IPC-2221

Generic Standard on Printed Board Design

Amendment 1

Amendment 1
January 2000

Figure 8-16 Round or flattened (coined) lead joint description

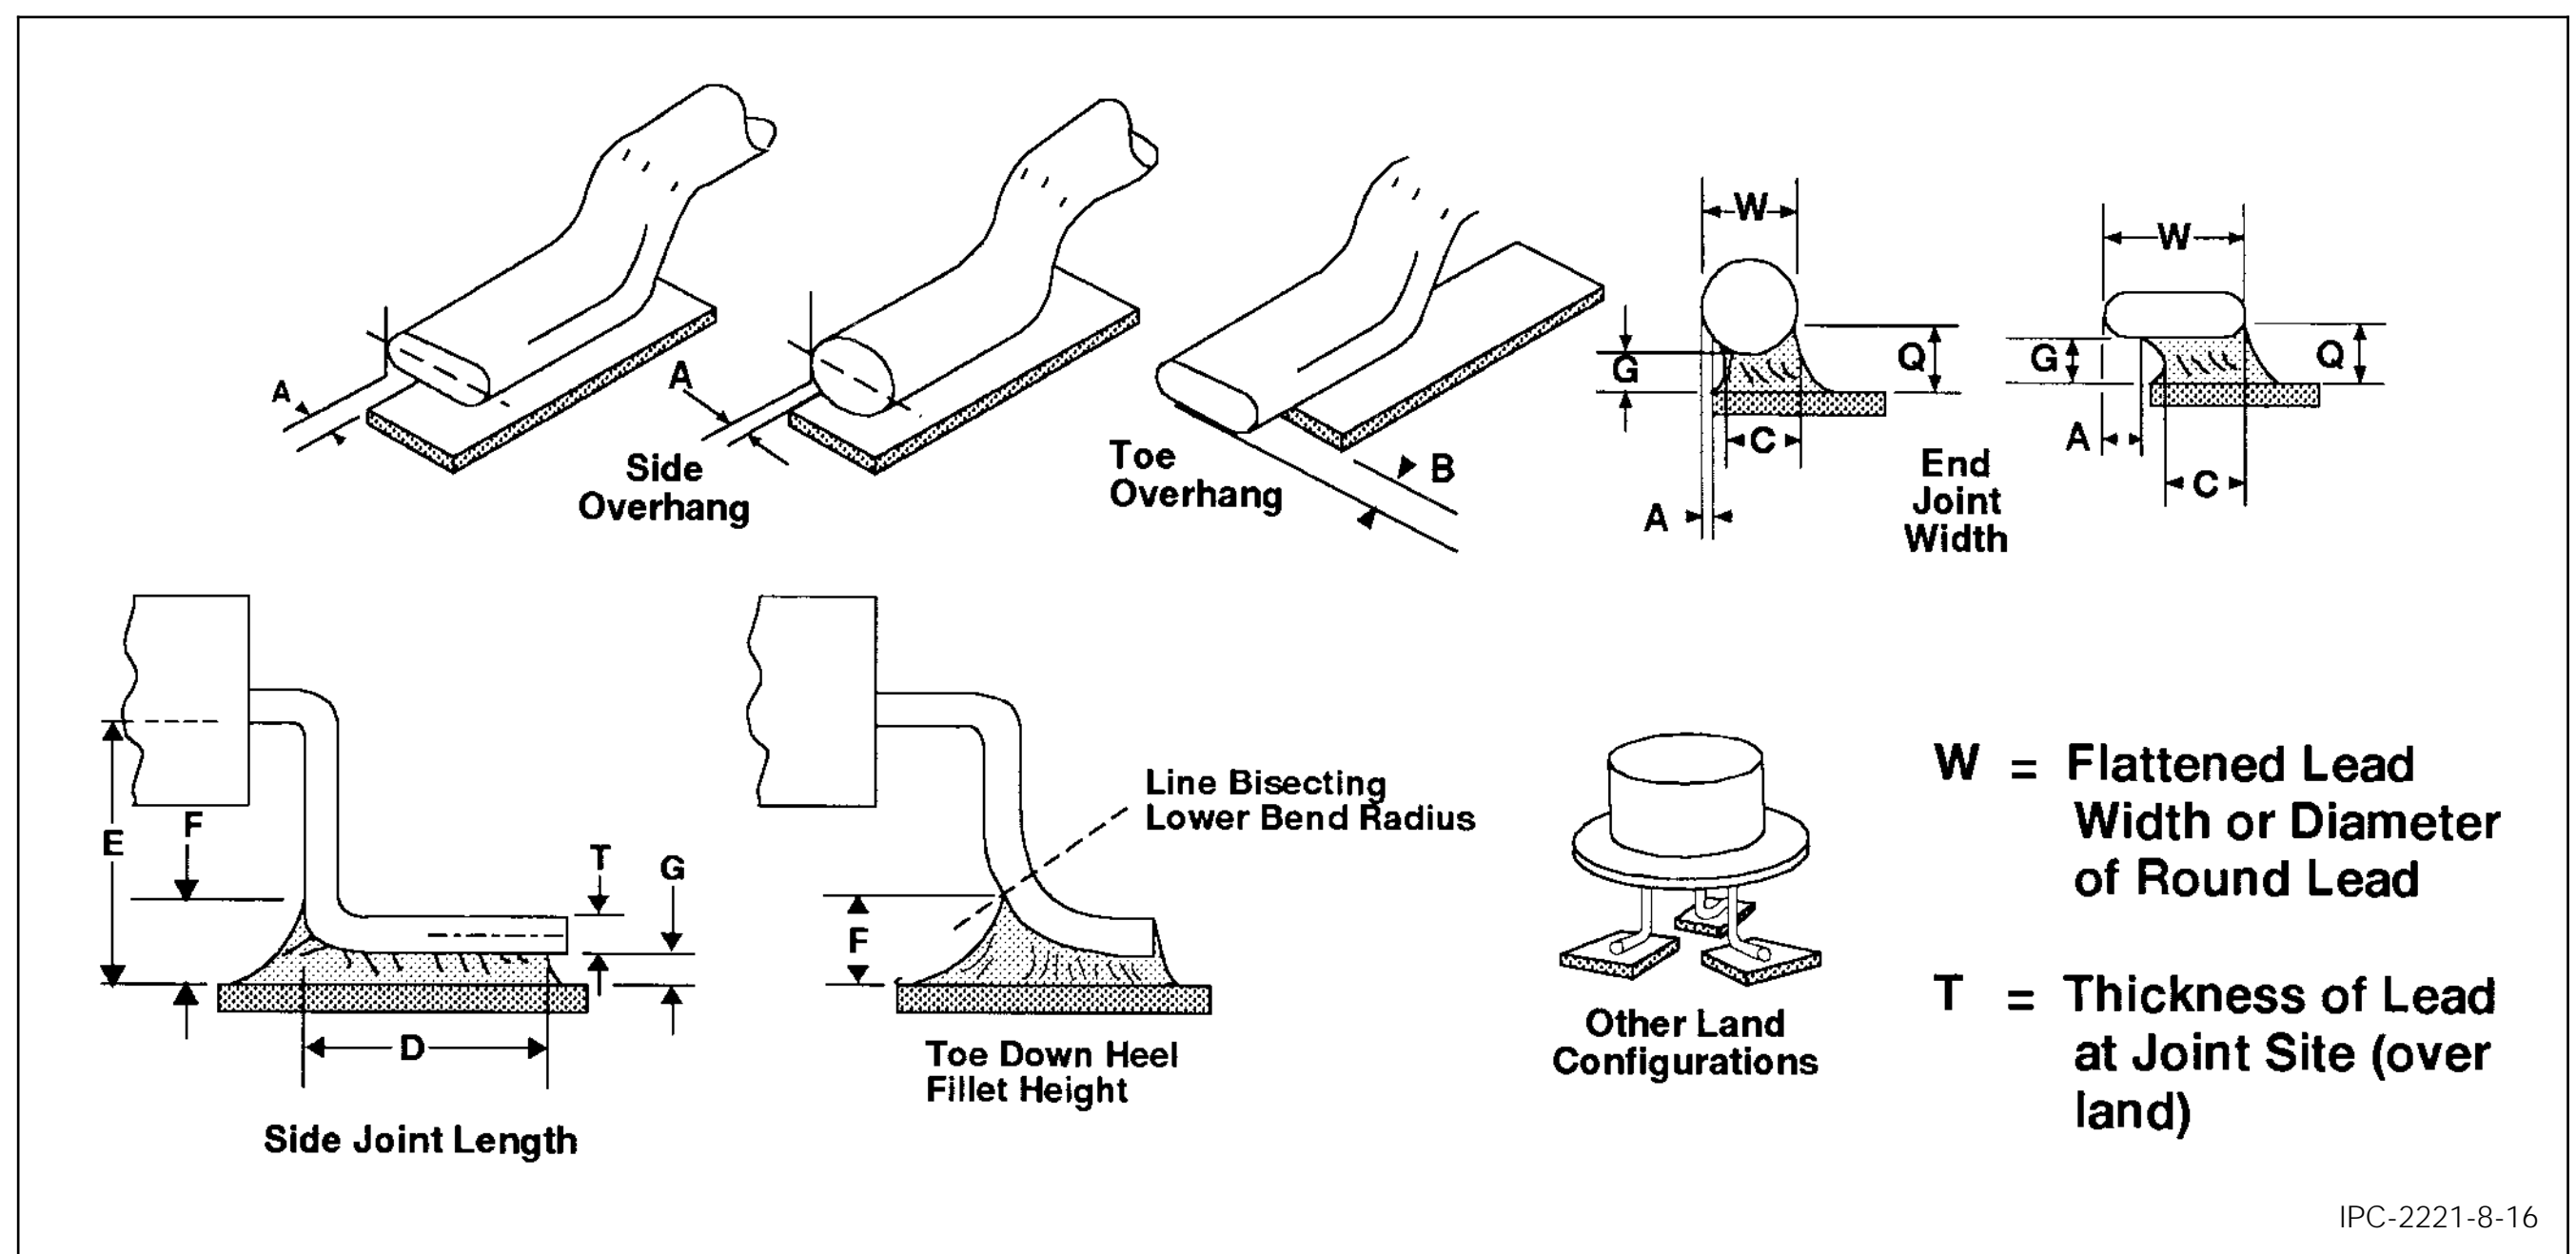
Replace Figure 8-16 as follows:

Figure 8-25 "TO" can radial-leaded component, mm [in]

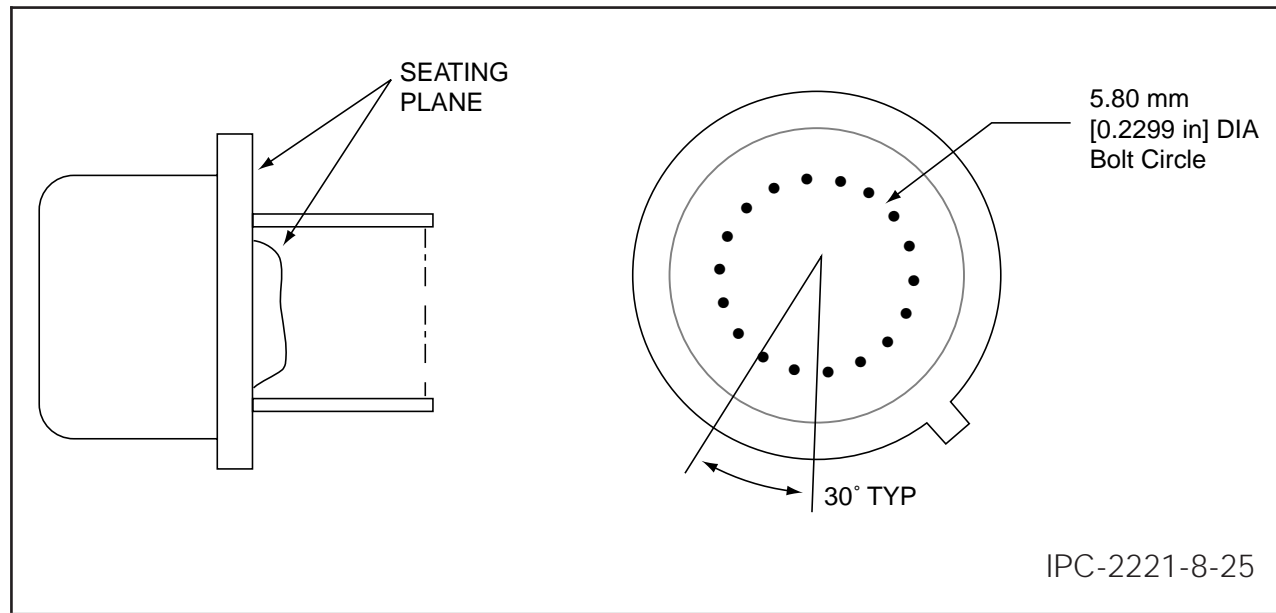
Replace Figure 8-25 as follows:

Figure 10-3 Etched Conductor Characteristics

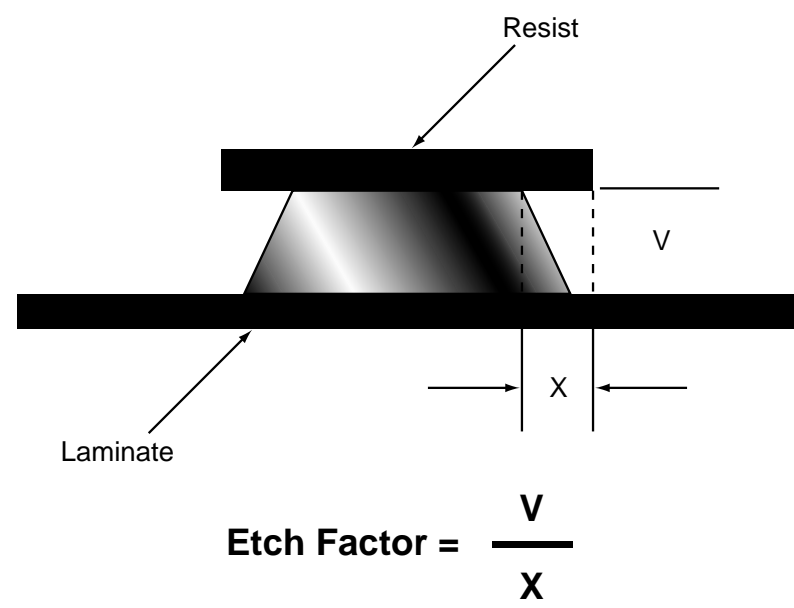
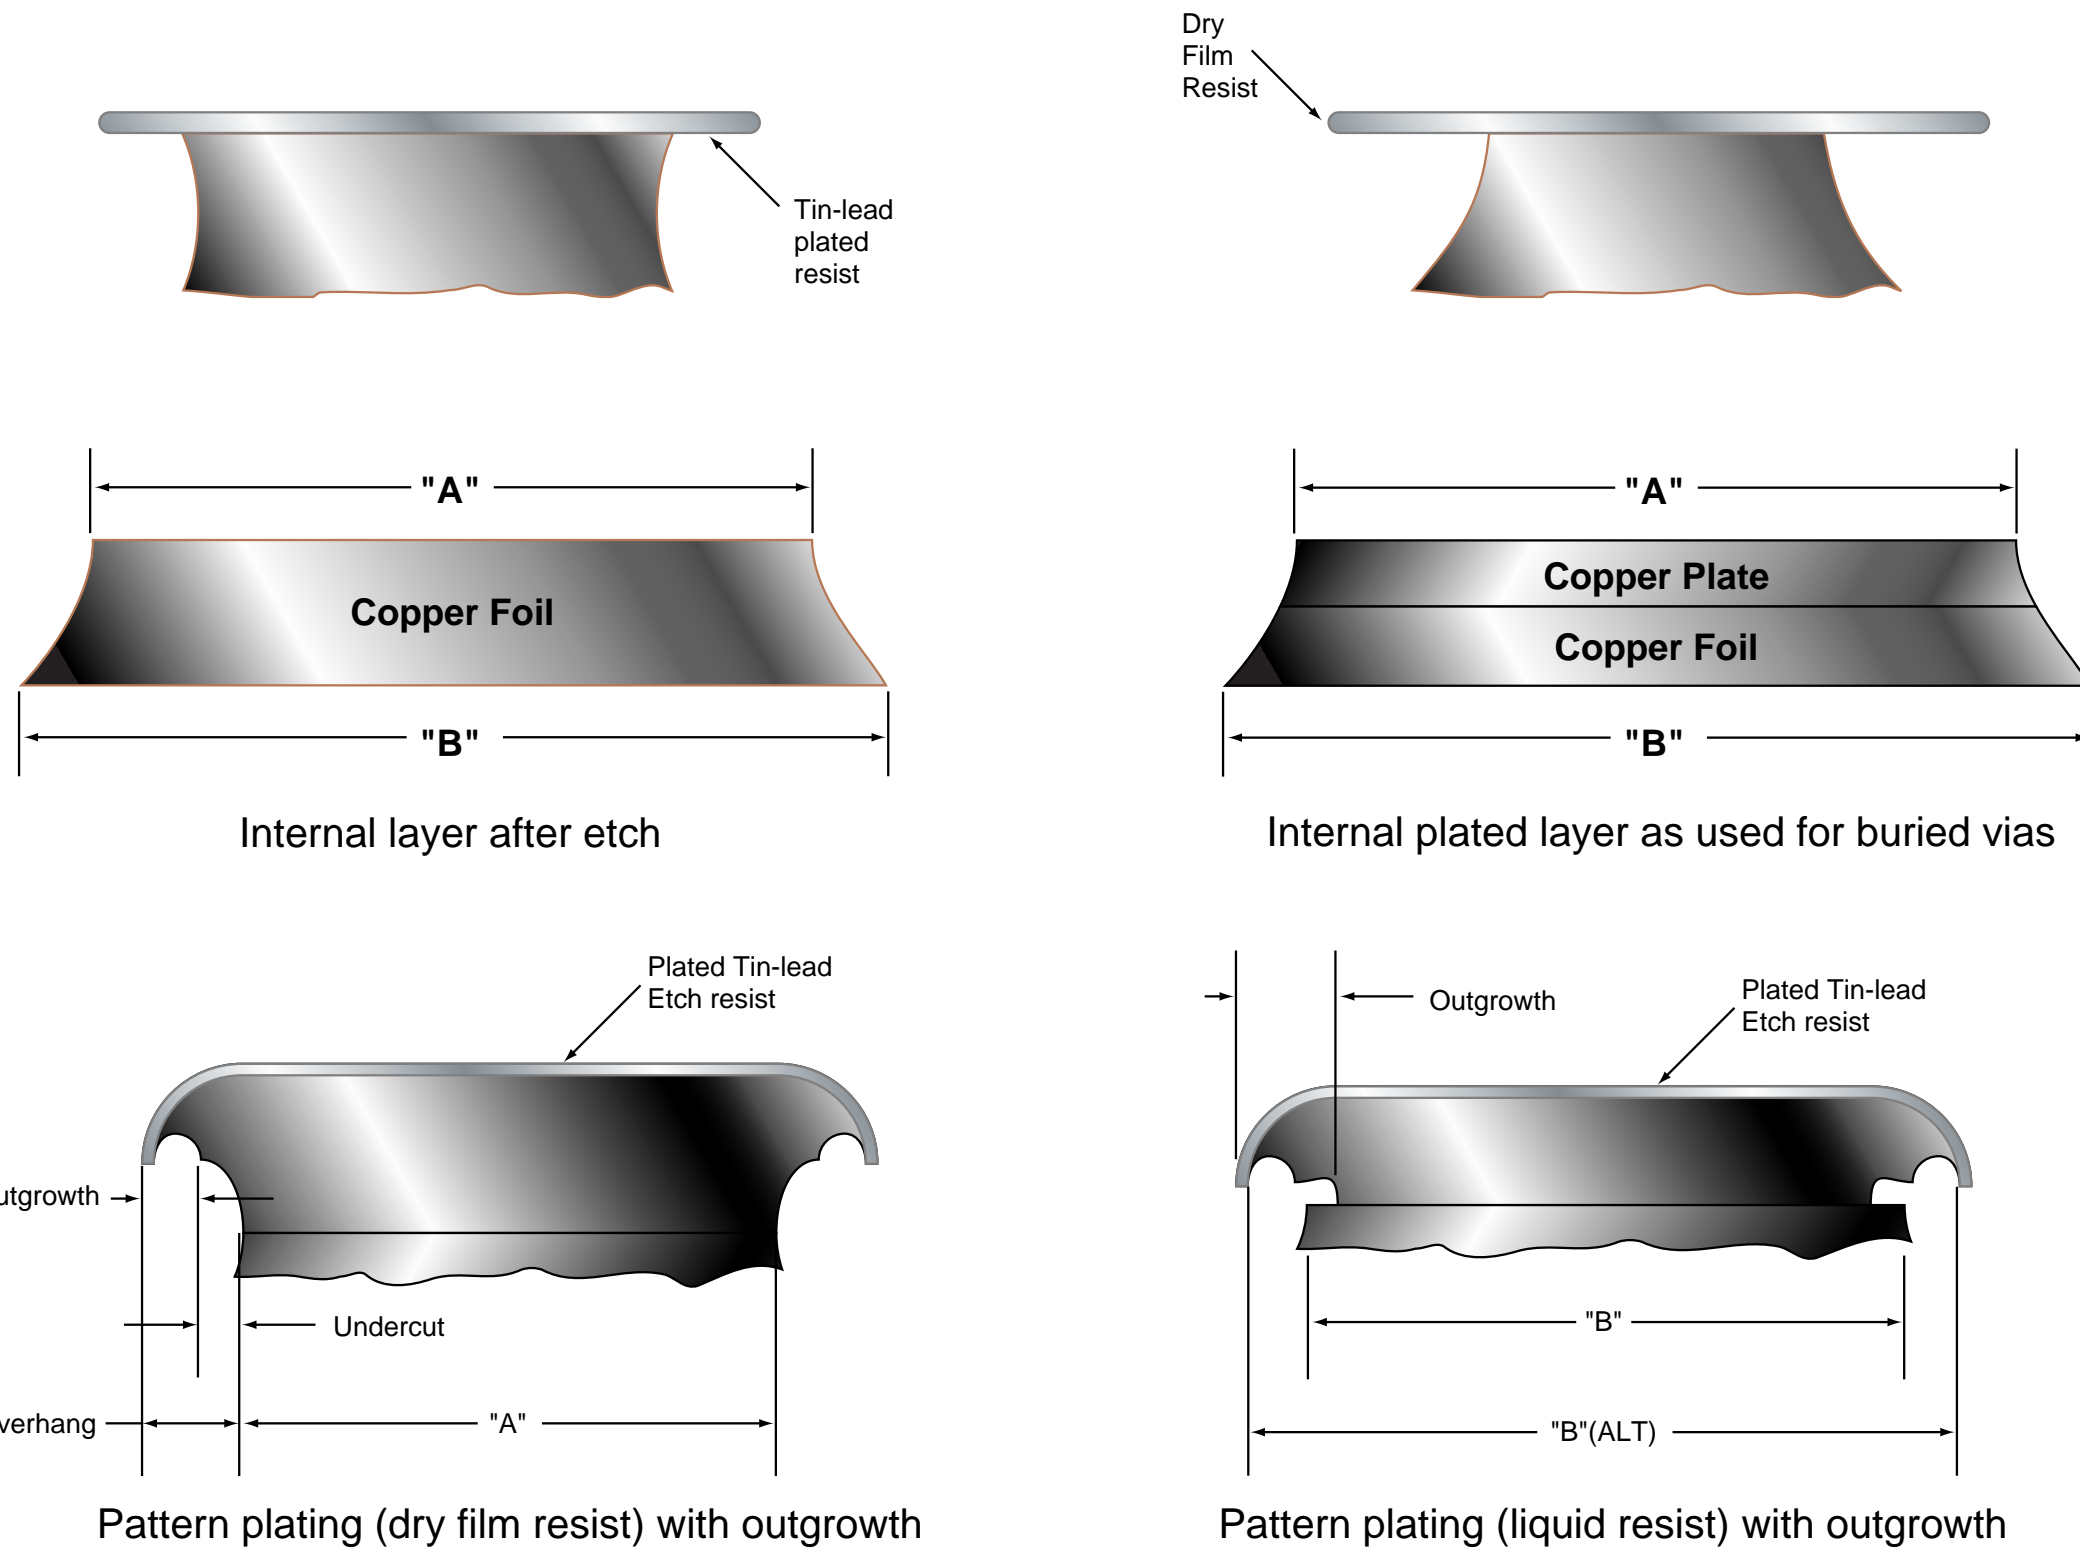
Replace Figure 10-3 as follows:

"A" POINT OF NARROWEST CONDUCTOR WIDTH: This is not "Minimum Conductor Width" noted on master drawings or performance specifications.

"B" CONDUCTOR BASE WIDTH: The width that is measured when "Minimum Conductor Width" is noted on the master drawing or performance specification.

"C" PRODUCTION MASTER WIDTH: The width usually determines the width of the metal or organic resist on the etched conductor.

Design width of the conductor is specified on the master drawing and is most often measured at the conductor base "B" for compliance to "minimum conductor width" requirements.

Note: The extent of outgrowth, if present, is related to the dry film resist thickness. Outgrowth occurs when the plating thickness exceeds the resist thickness.

"B" (ALT) would be used to determine compliance with "Minimum Conductor Width" for this etch configuration.
